1. How does the IO subsystem meet the general requirements of any subsystem? This should be spelled out in a separate Preliminary Design Document.
-

2. The Design Requirements Document needs a careful reviewing to update it...

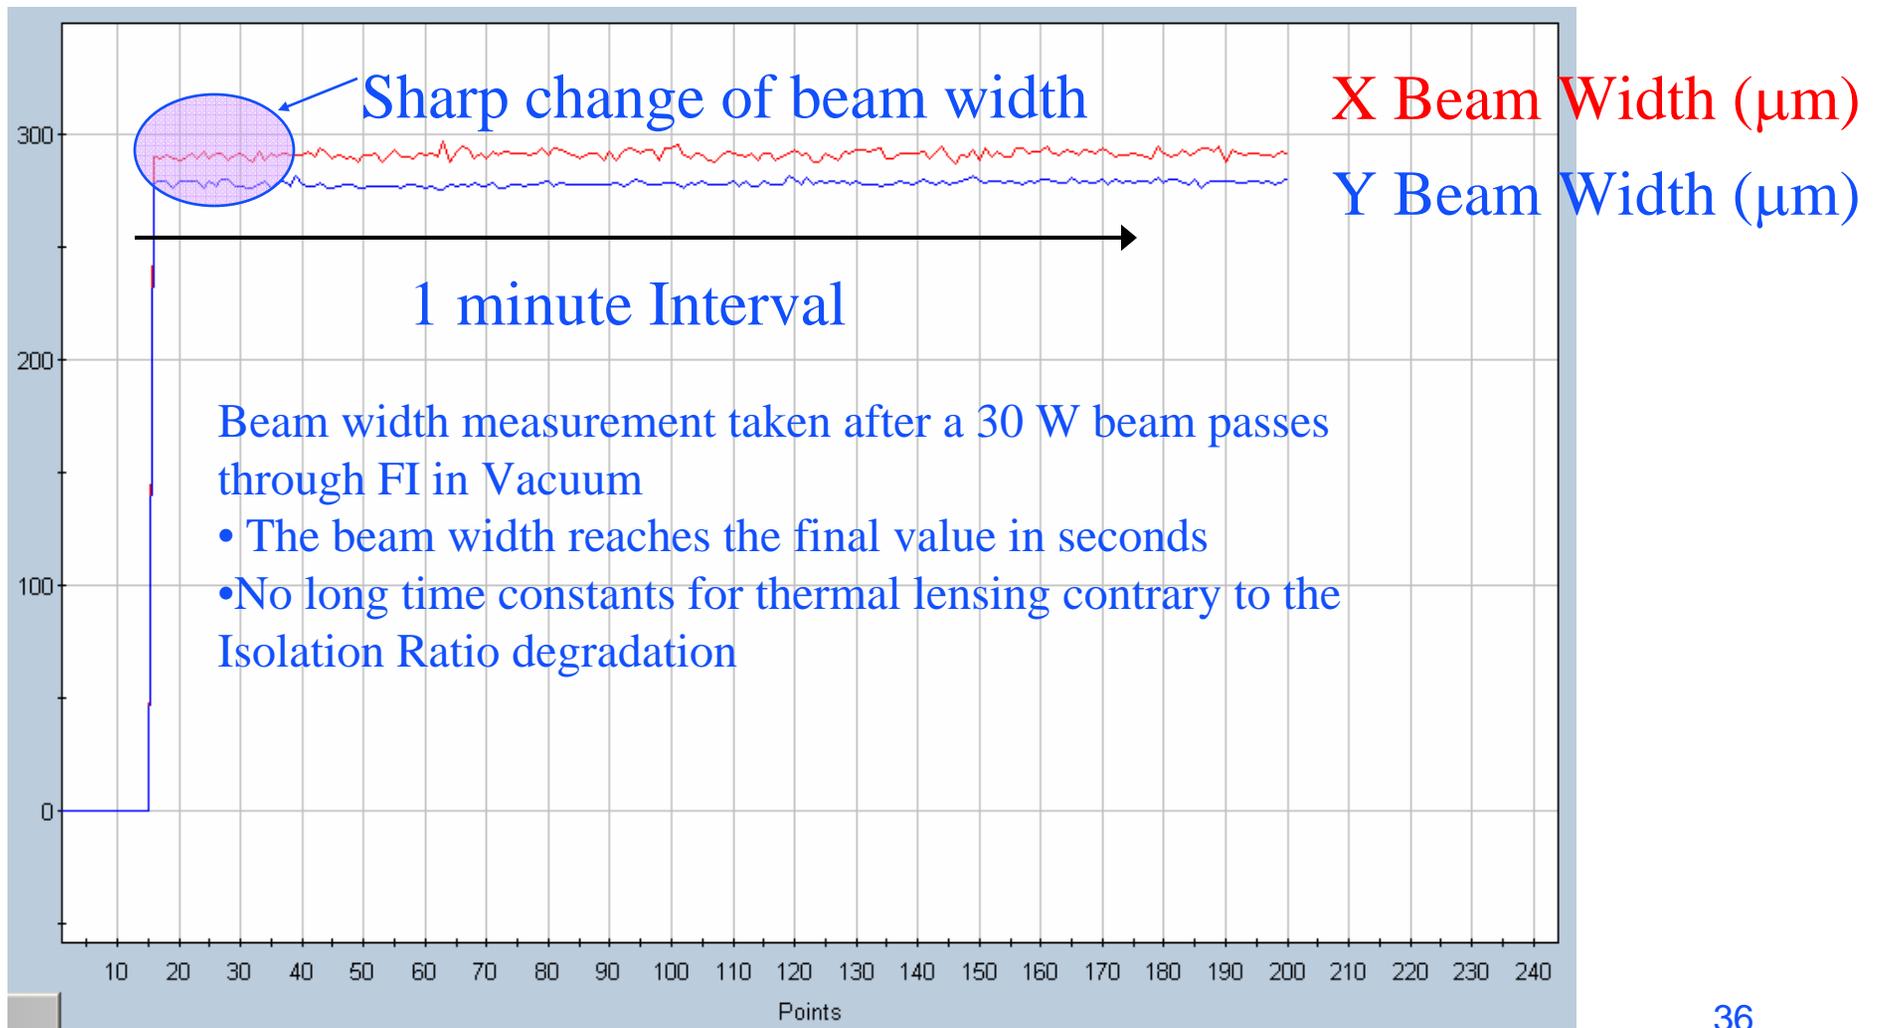
44. In Table 15, is the value of 4 mm for the tolerance of the MC waist a typo? What is the correct tolerance?

Ans: Yes. The correct tolerance is $\pm 20 \mu\text{m}$. This is more than twice of the expected change in IMC waist size due to thermal effects.

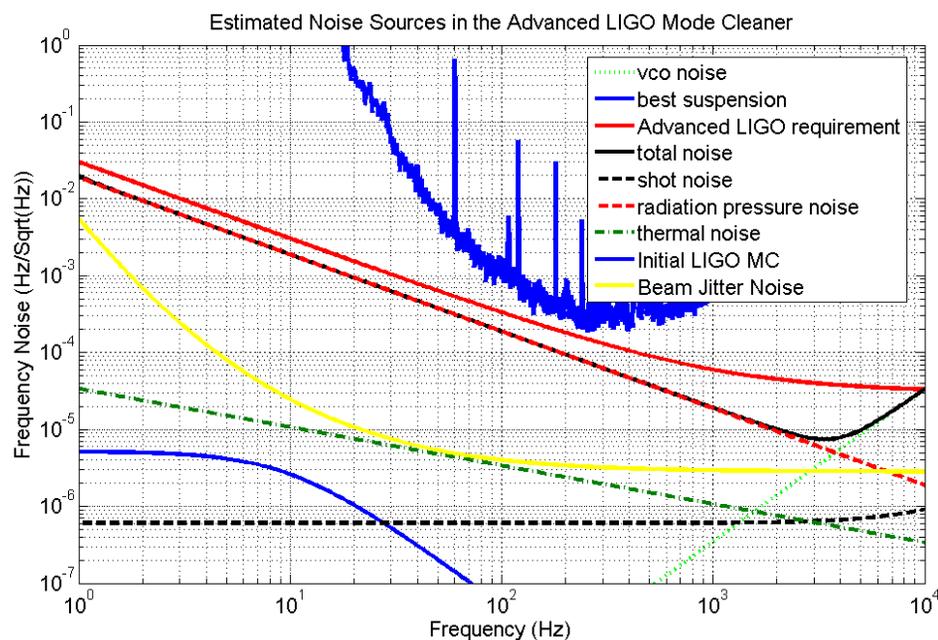
49. Does the total noise in Figure 7.4 exceeding the requirement above 3 kHz cause concern? Can the VCO noise be improved to increase the crossing frequency?

➤ The initial theoretical model was assuming a very conservative estimate

➤ Assumed 100% SB phase noise to carrier phase noise coupling.

➤ We relaxed that to 10% SB phase noise coupling requiring a SB amplitude asymmetry of less than 10% (still conservative).

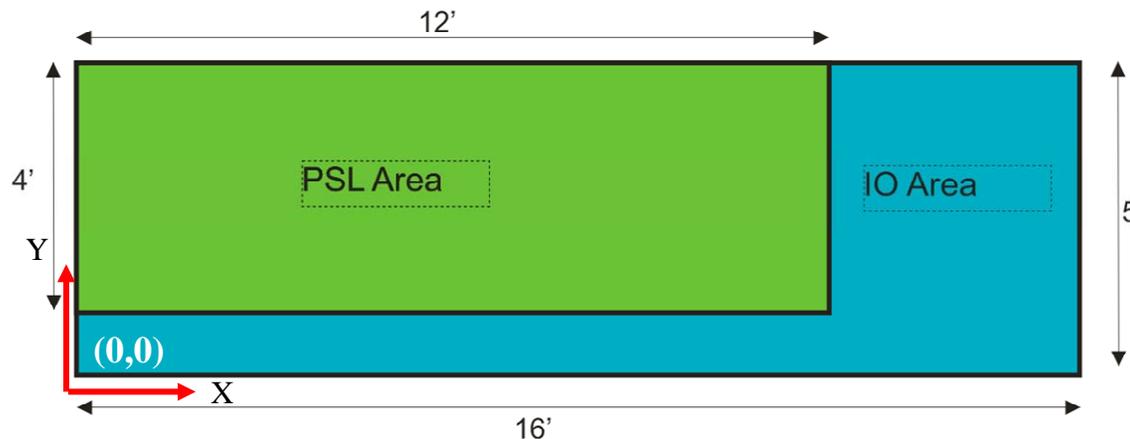
80. Has the layout in Figures 3 and 4.1 been approved by PSL? It appears that this layout needs to be mirrored along the Y-axis due to some cabling issues associated with high power laser.

- Initial response from PSL team was positive, but
 - » PSL group has not developed a detailed layout yet,
 - » does not yet know if it can fit in the baseline layout shown below
- Some space can be saved in the IO area by using tubular periscope, changing the 12' dimension to 13'.
- A larger table may be required.
